Generic protection standards for unprecedented development

The Outline Soil Management Plan, Kent (7.5.10.2) and the Applicant's responses treat sensitive marsh soils of the former Wantsum Sea Channel in a generic manner. Development on a former sea channel that is now fresh water is unprecedented globally.

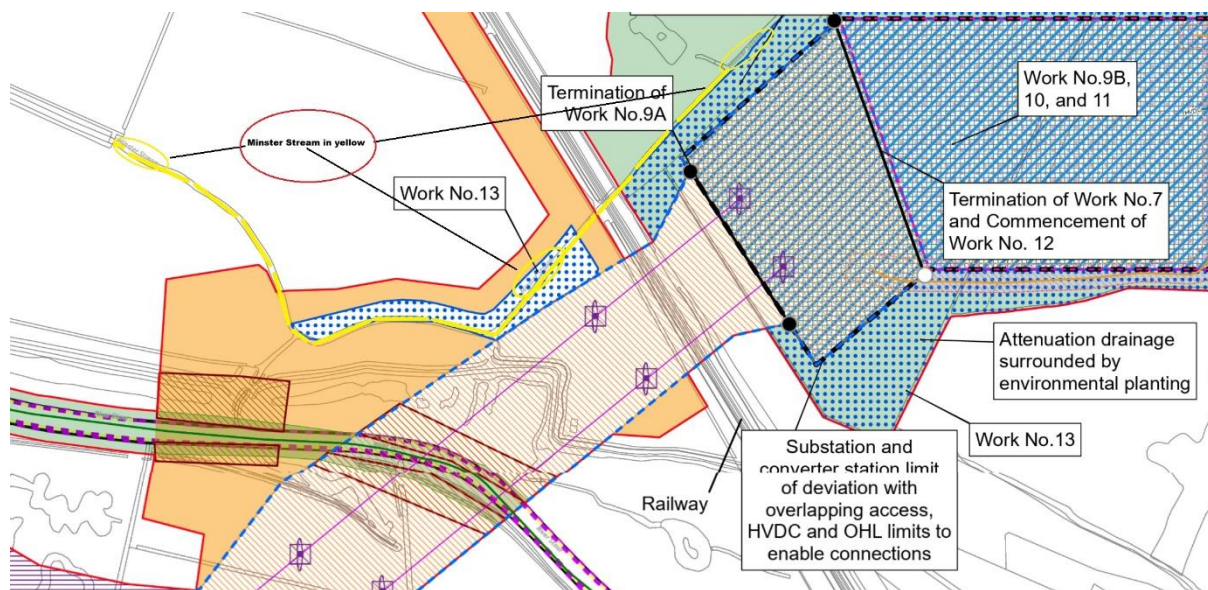
Failure Point	Technical Issue	Practical Consequence
Groundwater Hydraulic Lock	The high water table (as seen in Feb 2026 floods) exerts upward pressure.	If you dig a pond, it fills with groundwater from below before it can take any road runoff. If you line it, the pressure can "pop" the liner (hydrostatic uplift).
Discharge Blockage	The receiving ditches (Minster Stream network) are	The ponds cannot discharge their water because the stream level is higher than the pond outlet. The ponds act as "storage tanks with no drain,"

Soil "Pudding"

The clay soil loses structure when wet and trafficked.

Construction vibration on wet clay turns the soil next to the road into liquid mud ("thixotropy"). This mud slides into the drainage swales, blocking them and forcing water to pool on the arable land, destroying crops and soil structure.

An ALS soil survey has only recently been conducted. I request that the results of this survey (together with any further intrusive ground investigations under REAC GH01) are applied to produce a detailed, site-specific reinstatement plan. This plan must be submitted, consulted on and secured in the final CEMP, updated Outline Soil Management Plan before the end of the DCO process (and before any works commence)

It should include:

pre- and post-construction soil testing and monitoring specific to min-till practices; tailored handling, storage and reinstatement methods to protect soil structure; full reinstatement of field drainage and avoidance of compaction or salination; and independent verification that the reinstated soil meets or exceeds its pre-construction condition.

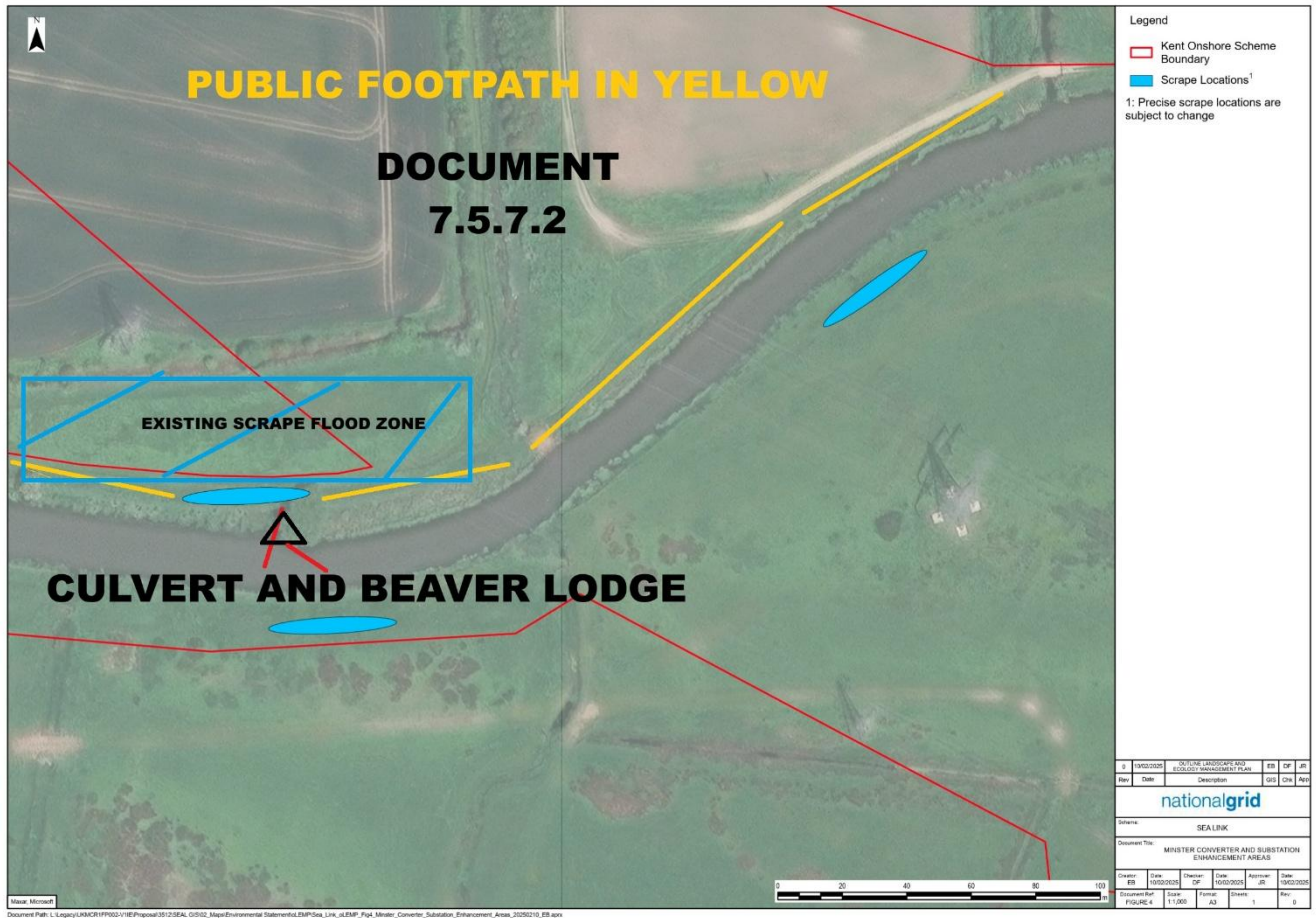
Existing wetland scrapes adjacent to the River Stour and temporary bridge crossing My HLS/SFI agreements include wetland scrapes north of the River Stour (Abbey Farm Wetland) that we actively manage for biodiversity in an agreement with Natural England.

The temporary clear-span bridge over the River Stour, associated haul roads and construction traffic will directly affect these scrapes. The Applicant's response (9.36 Table 19.1, point WR-REP2-101.05) states that schemes "will not be impacted" or will be covered by the Compensation Code, but provides no site-specific plan for protection of my existing scrapes wildlife during bridge works, pre- and post-construction monitoring.

I request a site specific Construction Method Statement for the bridge crossing (with measures to avoid damage to existing scrapes and river bank (Nemo Link left lasting damage)), updated REAC entries for monitoring and reinstatement of scrapes to the same or better condition.
